Work Order ID 102423

Item Name: Crosstube Aft

DRAWING NO. D412-664-243	TITLE CROSSTUBE ASSEMBLY (412 HI AFT)	REV. E	DART AEROSPACE LTD ENGINEERING ORDER		D.E.O. NO. D412-664-243-E-4	SHEET NO. SHEET 1 OF 3	SCALE NTS
DRAWN 90	CHECKED A	MFG. APPR. A	APPROVED MP		DE APPR. MP		
DATE 12.08.21	DATE 12.08.30	DATE 12.08.30	DATE 12/8/30		DATE 12.08.30

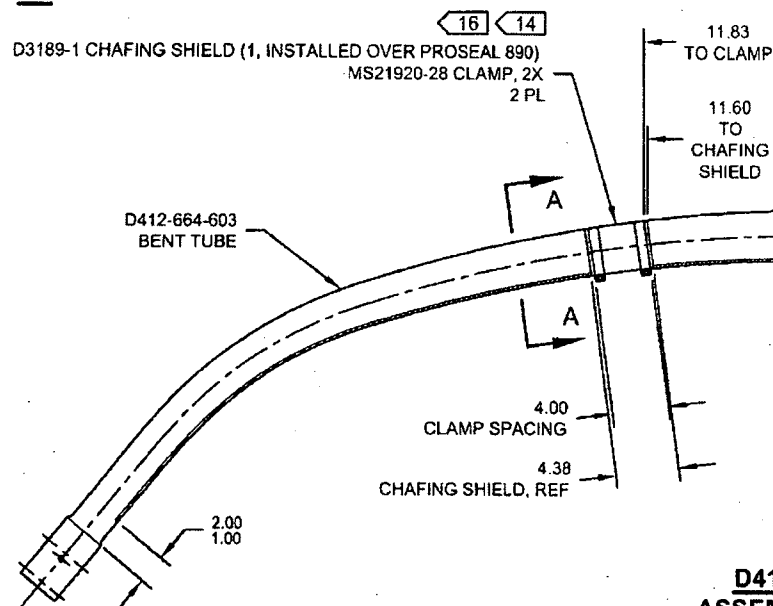
**NOTES 2, 14, AND 16 ON SHEET 1 ARE AMENDED AS FOLLOWS:**

**WAS:**

- 2) FINISH: CHEMICAL CONVERSION COAT PER DART QSI 005 4.1  
PRIME INSIDE AND OUTSIDE PER DART QSI 005 4.2  
MASK UNDERSIDE OF CROSSTUBE AS SHOWN (HATCHED AREA)  
PAINT OUTSIDE PER DART QSI 005 4.2  
AFTER PAINTING, APPLY CLEAR COAT ON HATCHED AREA
- 14) APPLY A THIN COAT OF PROSEAL 890 ON INSIDE CONCAVE SURFACE OF D3189-1 CHAFING SHIELD AND LET CURE PER MANUFACTURER'S INSTRUCTIONS. INSTALL PROSEALED D3189-1 CHAFING SHIELD ONTO CROSSTUBE BY APPLYING A THIN COAT OF PROSEAL 890 ONTO CROSSTUBE. BE SURE TO ELIMINATE ANY AIR GAPS.
- 16) TORQUE CLAMPS ON D2896-1 SUPPORT 80 TO 100 IN-LB. **TORQUE CLAMPS ON D3189-1 CHAFING SHIELD 40 TO 50 IN-LB.** ENSURE AT LEAST 1.5 THREADS SHOWING IN SAFETY AND THAT NUT HAS NOT BOTTOMED-OUT AFTER TORQUING.

- 2) FINISH: CHEMICAL CONVERSION COAT PER DART QSI 005 4.1  
PRIME INSIDE AND OUTSIDE PER DART QSI 005 4.2  
PAINT OUTSIDE PER DART QSI 005 4.2
- 14) INSTALL D2856-600-1009 ABRASION STRIPS WITH A 0.13 REF GAP ON BOTTOM SIDE OF CROSSTUBE PER QSI 035.
- 16) TORQUE CLAMPS 80 TO 100 IN-LB. ENSURE AT LEAST 1.5 THREADS SHOWING IN SAFETY AND THAT NUT HAS NOT BOTTOMED-OUT AFTER TORQUING.

**D412-664-243  
ASSEMBLY DETAIL**

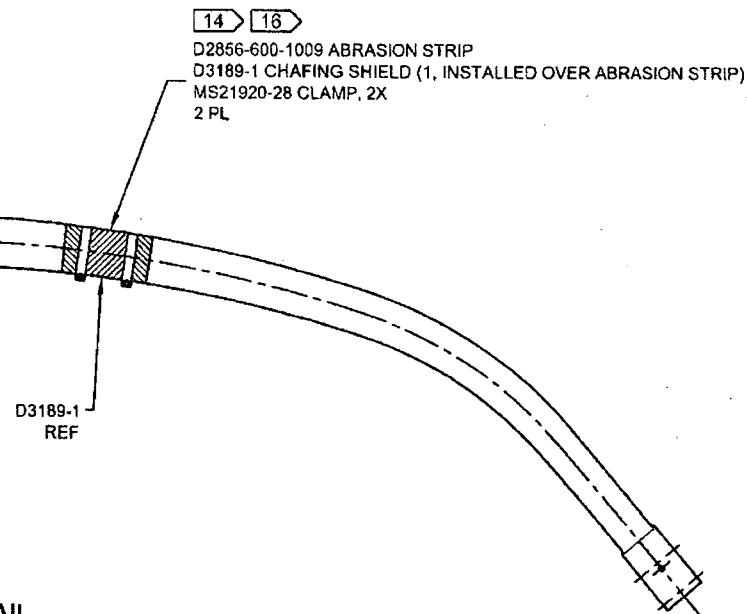
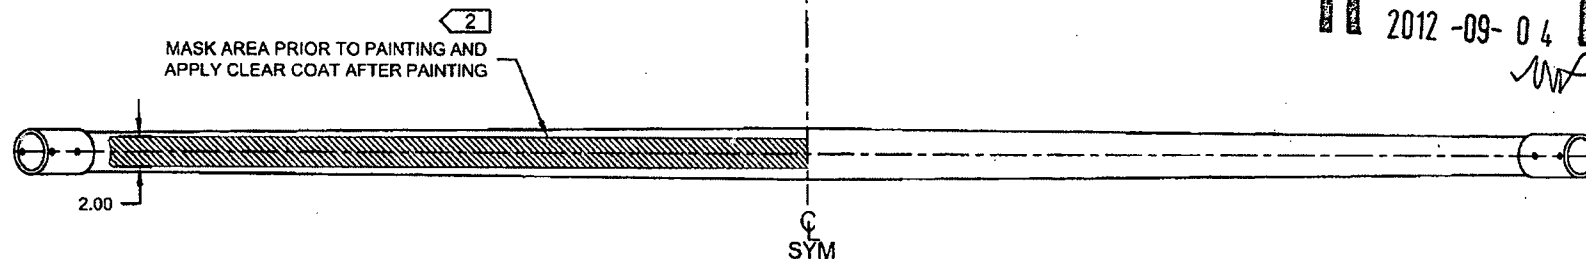
**IS:**

**WAS:**

**SECTION A-A**  
CHAFING SHIELD DETAIL  
VIEW ROTATED, NOT TO SCALE

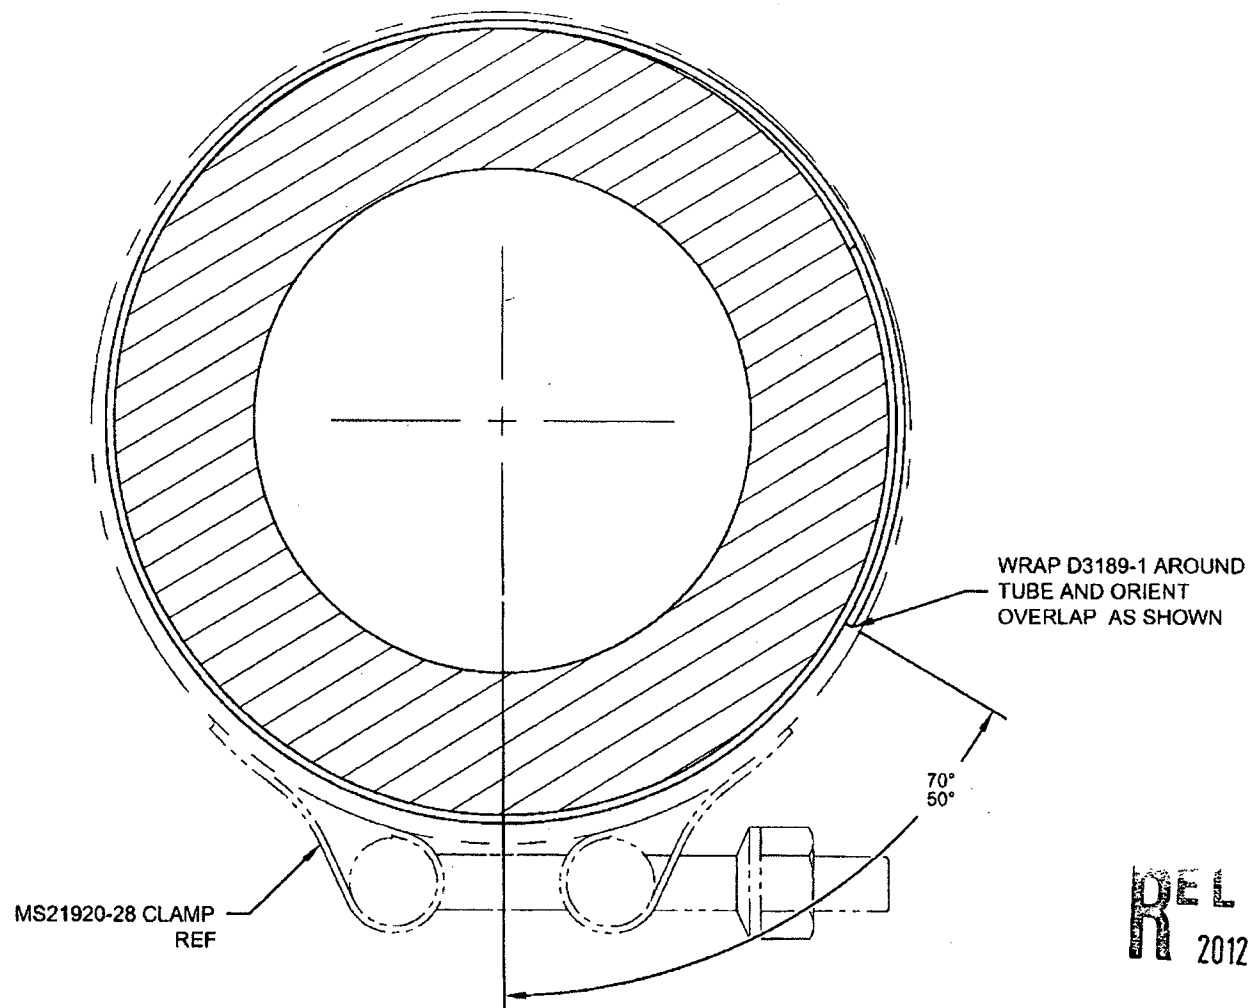
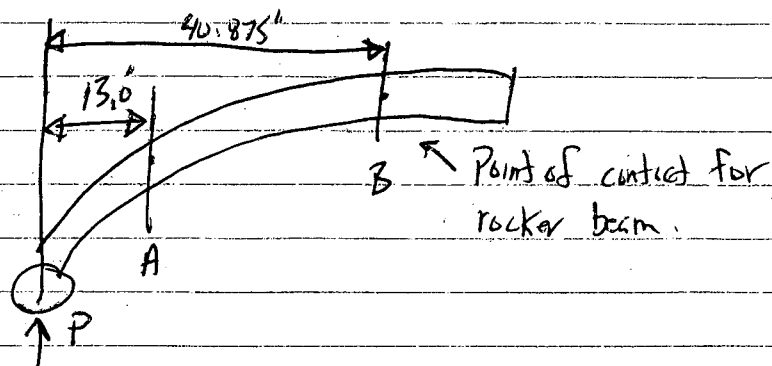
DRAWING NO. D412-664-243	TITLE CROSSTUBE ASSEMBLY (412 HI AFT)	REV. E	DART AEROSPACE LTD ENGINEERING ORDER		D.E.O. NO. D412-664-243-E-4	SHEET NO. SHEET 3 OF 3	SCALE NTS
DRAWN [Signature]	CHECKED [Signature]	MFG. APPR. [Signature]	APPROVED [Signature]		DE APPR. [Signature]		
DATE 12.08.21	DATE 12.08.27	DATE 12.08.29	DATE 12.08.29		DATE 12.08.29
